UNC Charlotte Phase 16

Addendum #4

Revision Narrative

2021-09-08

LEVEL 4 POWER PLAN - SOUTH

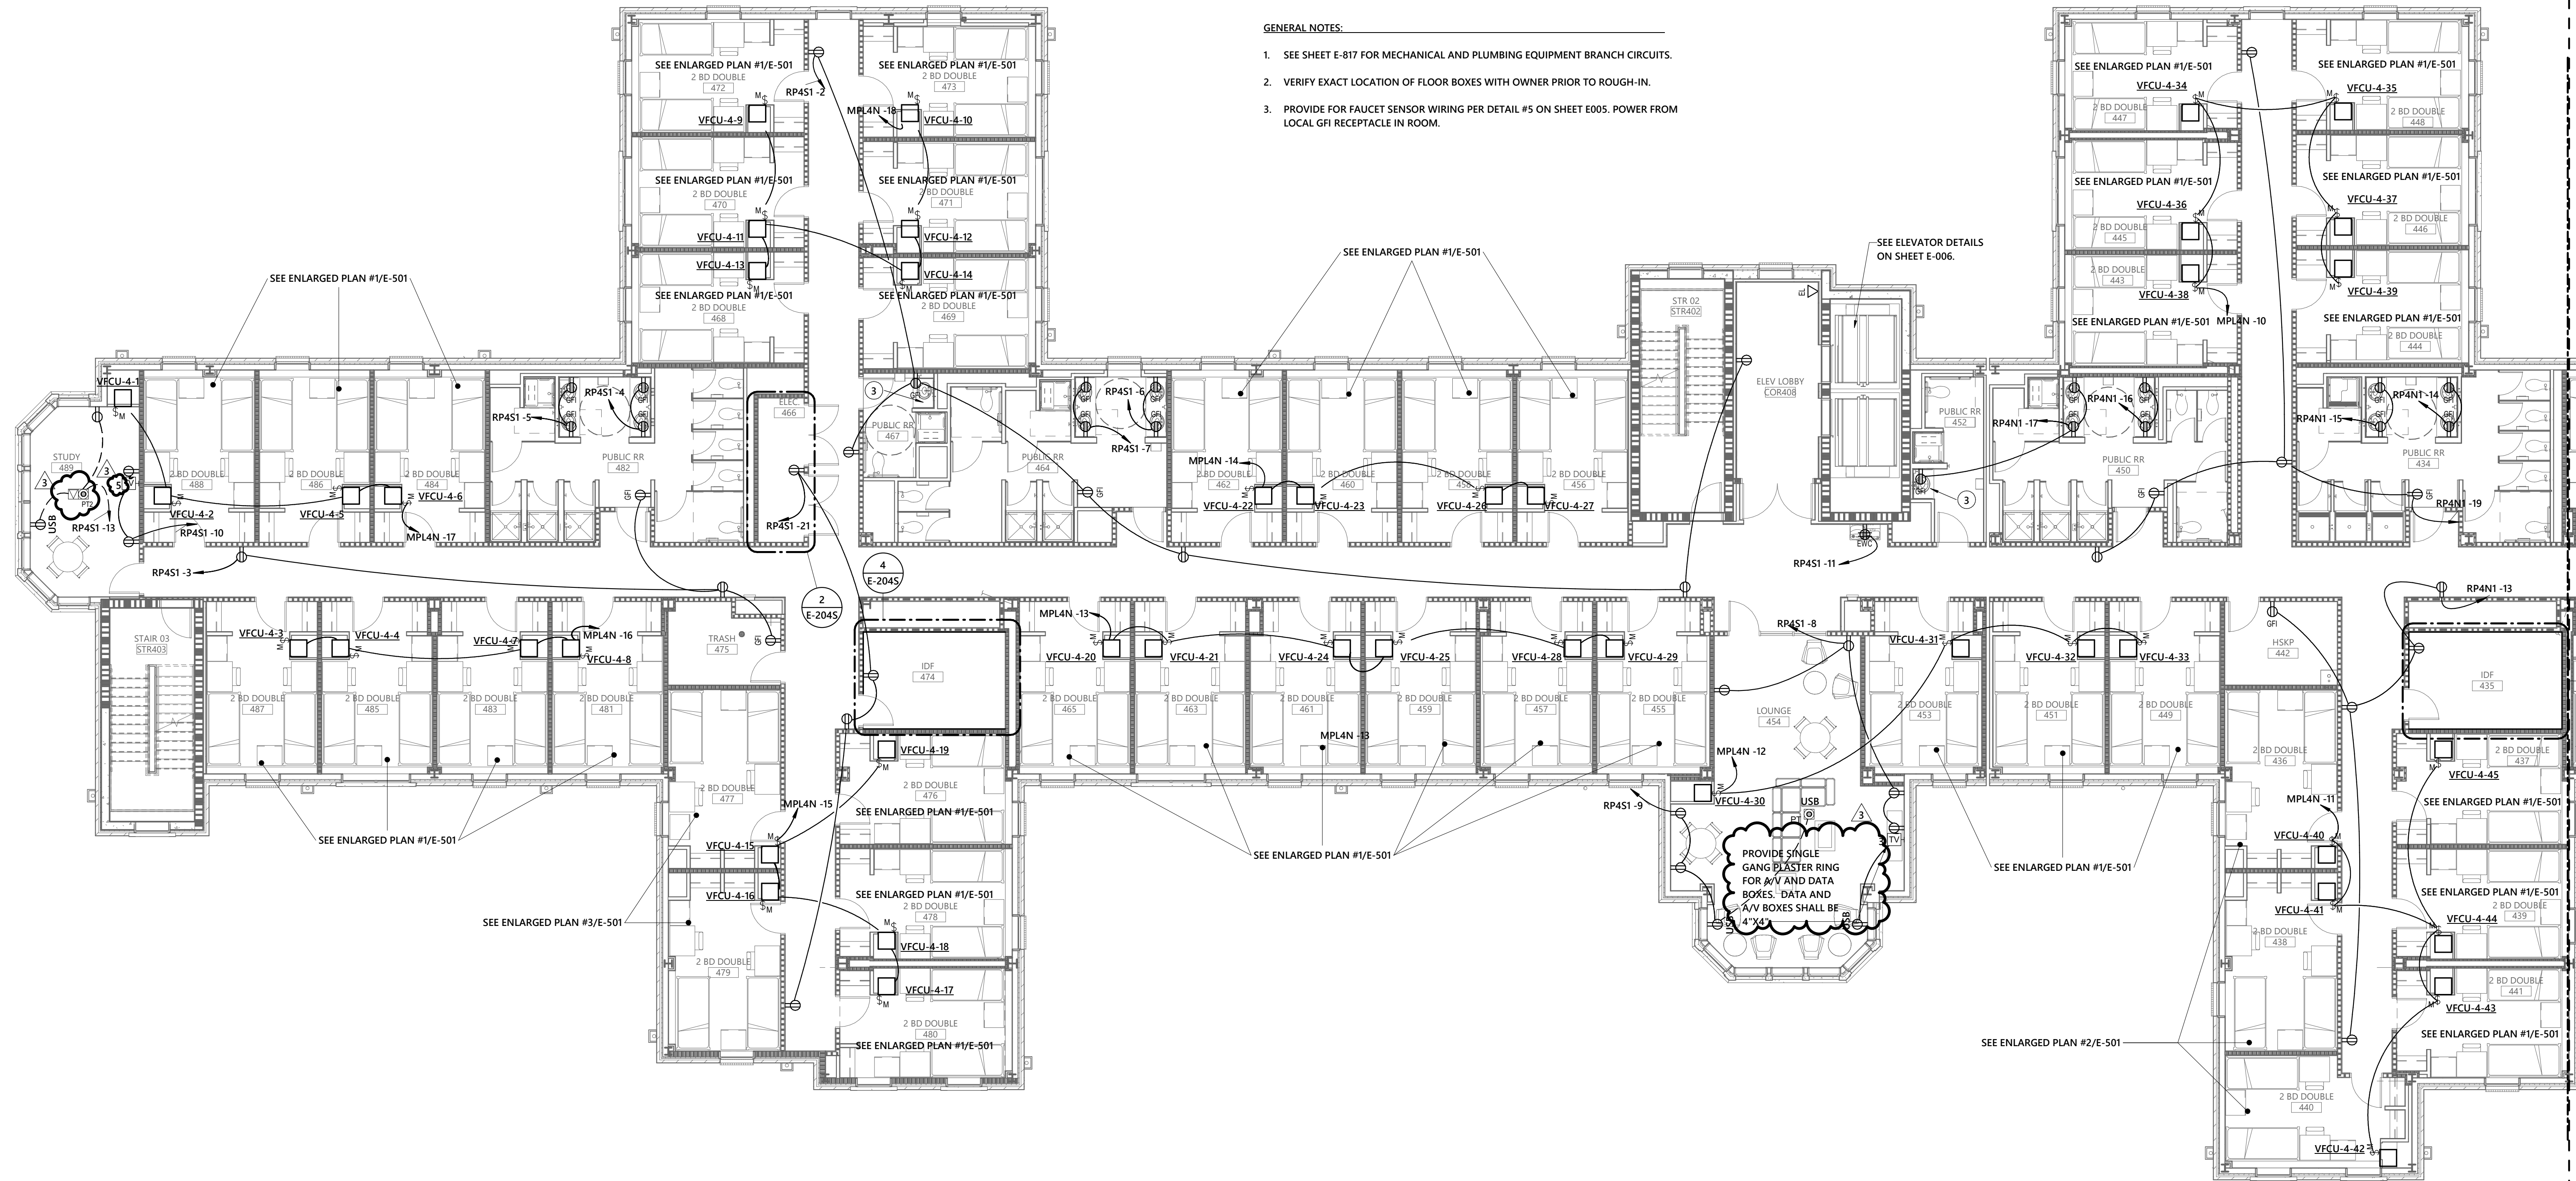
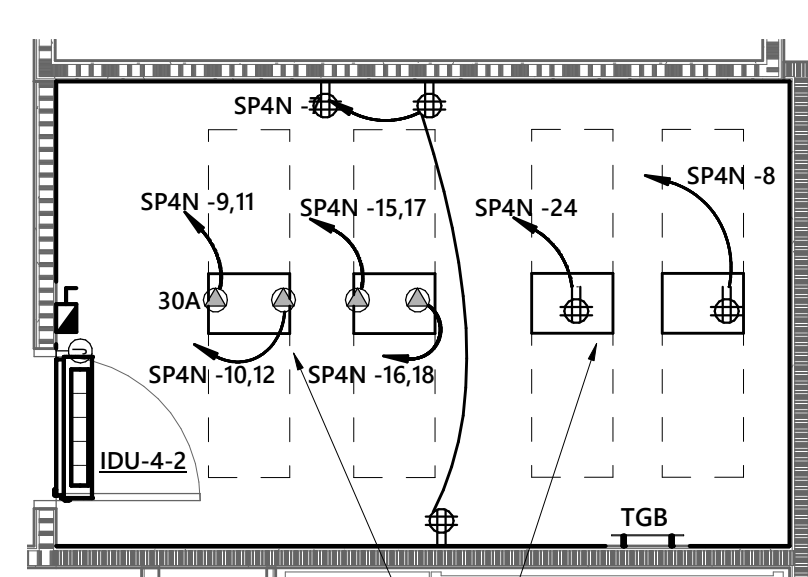
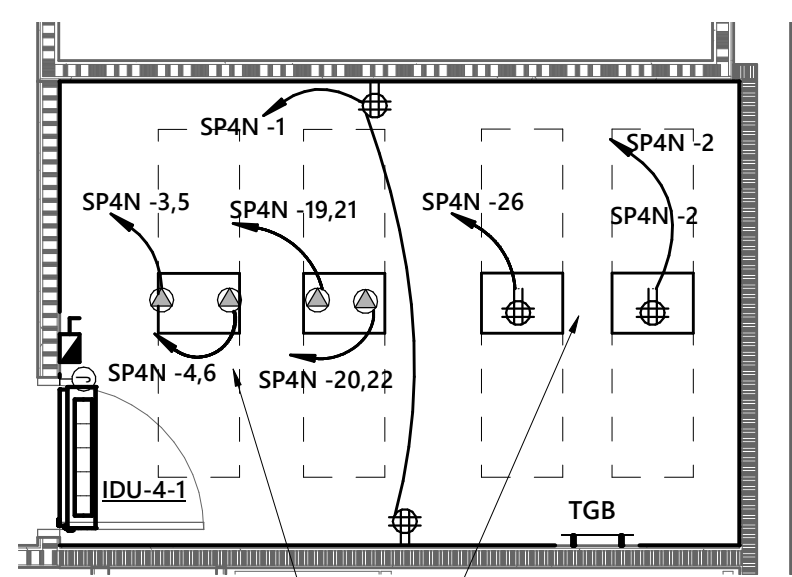
E-204S - Changed TV type. Added note for opening type of junction box. Poke thru type changed.

E-205N-A

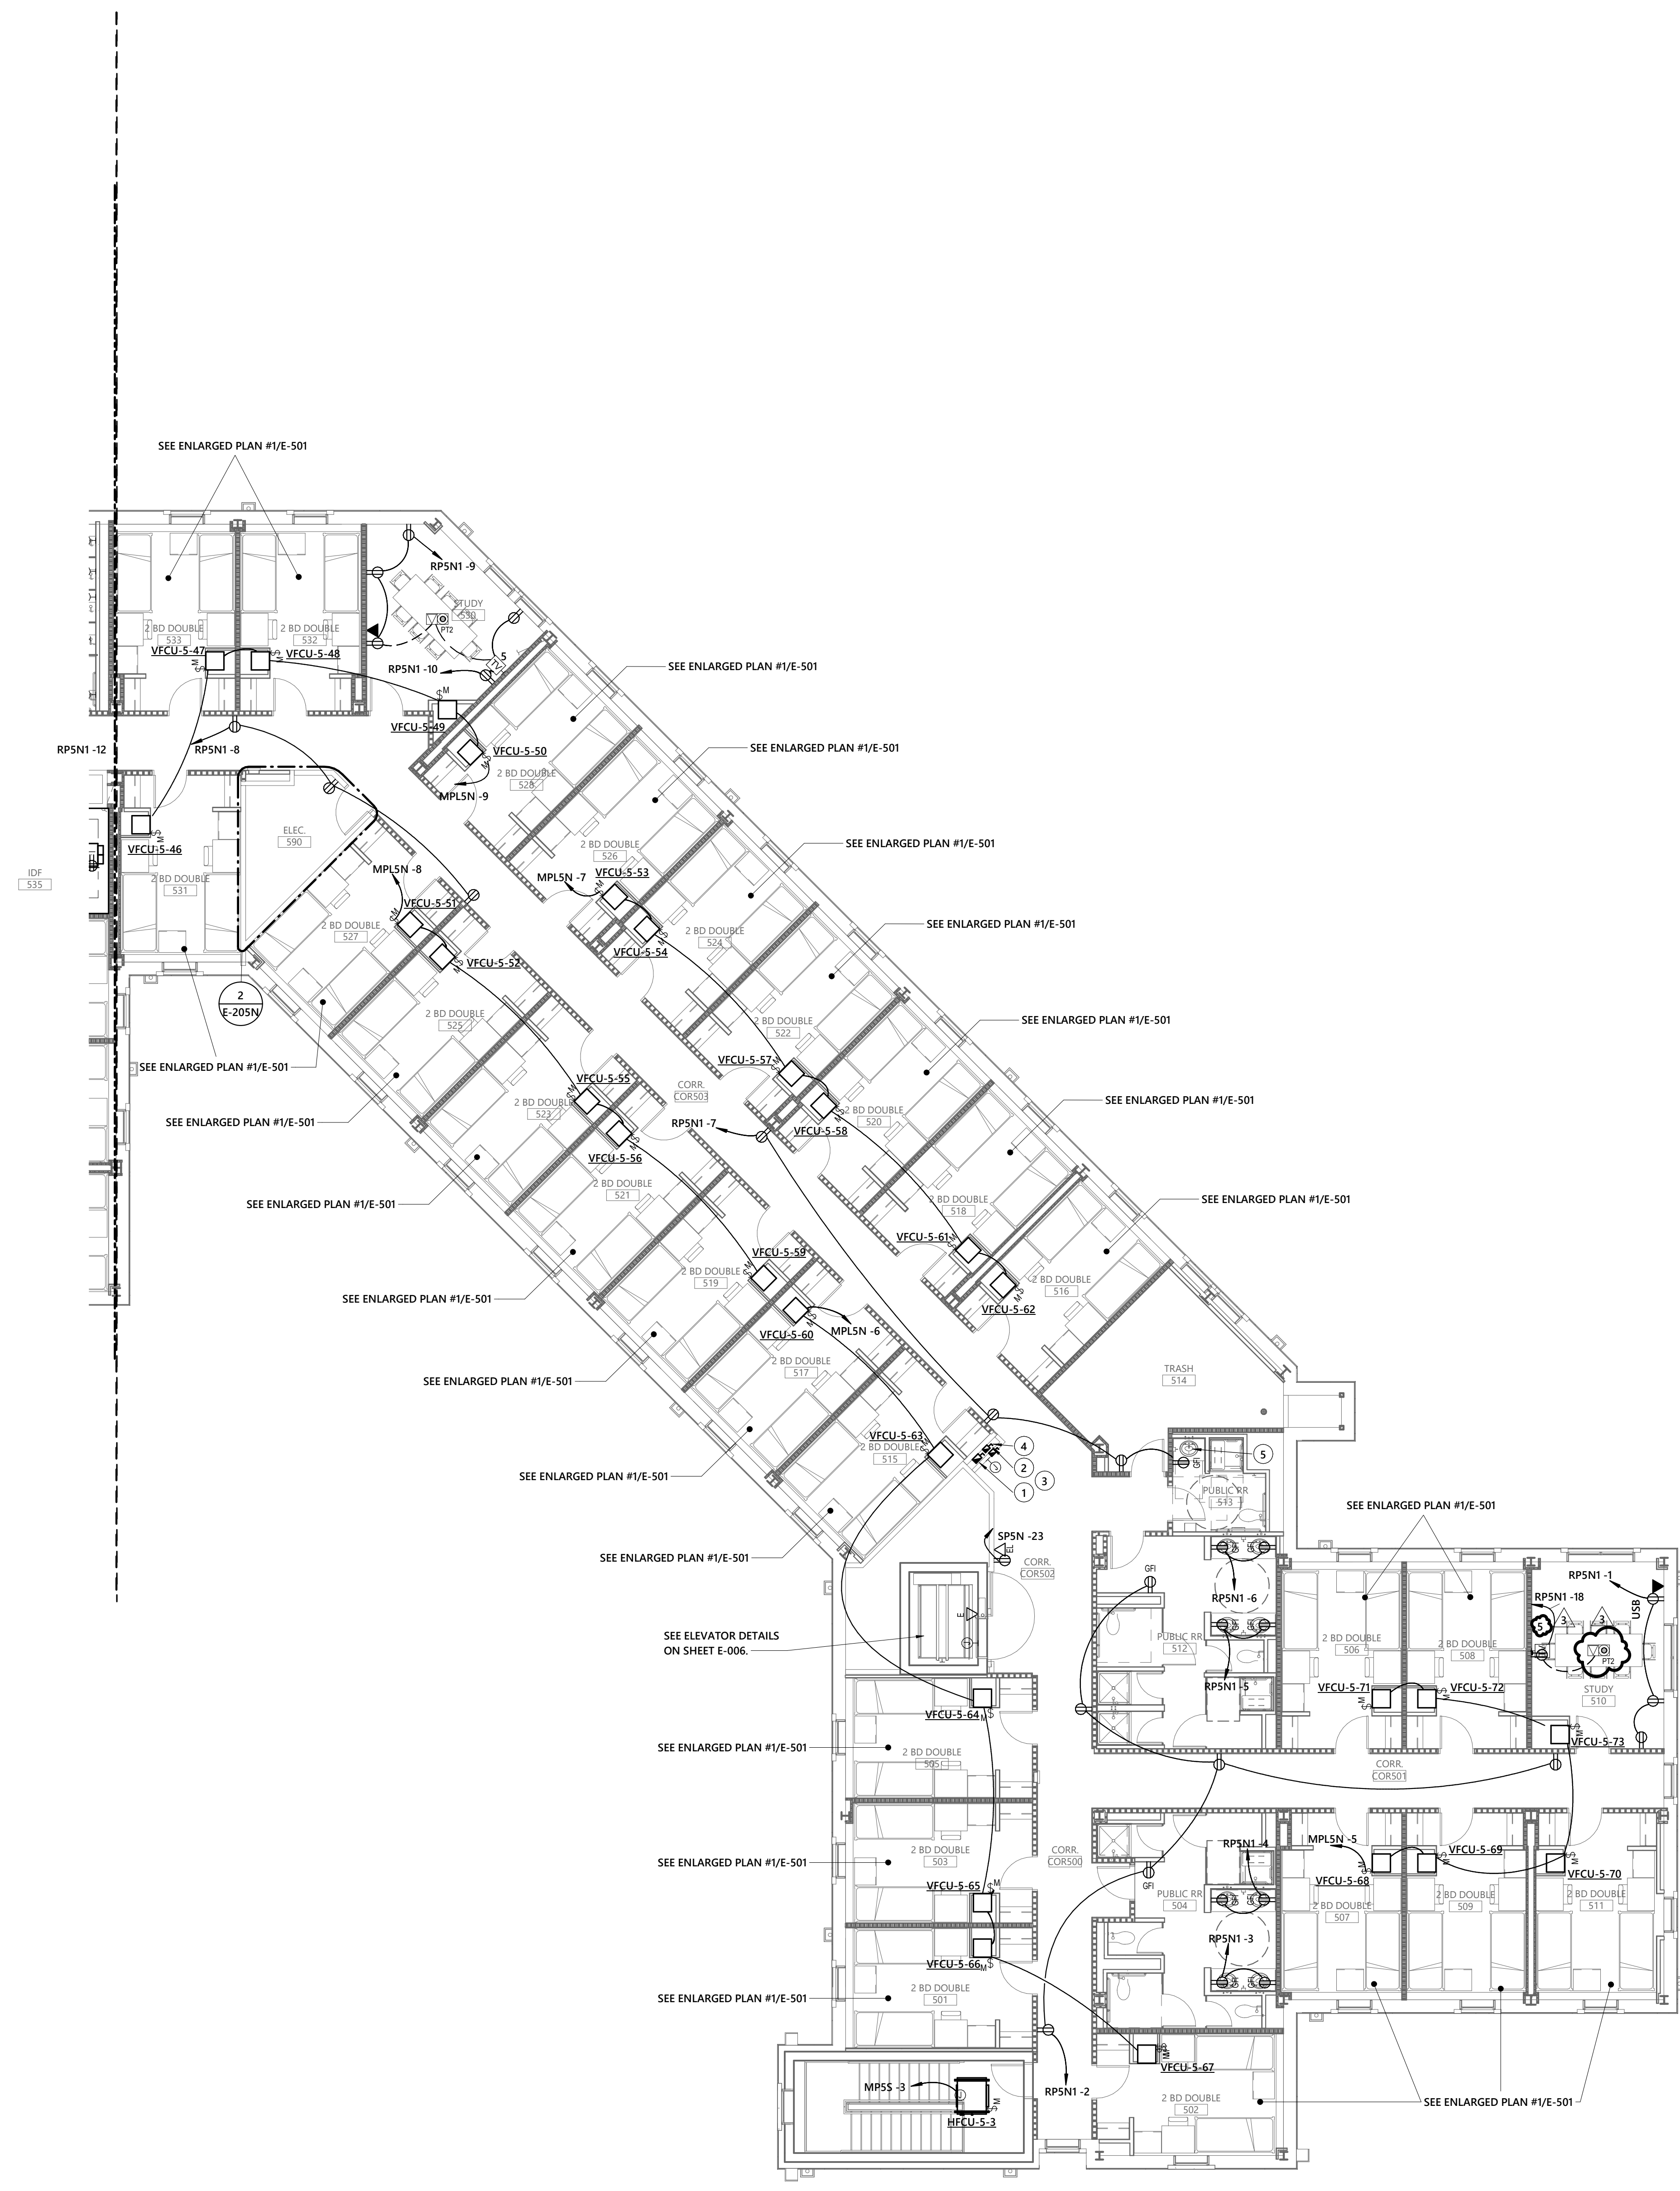
E-205N-A - Changed TV type. Poke thru type changed.
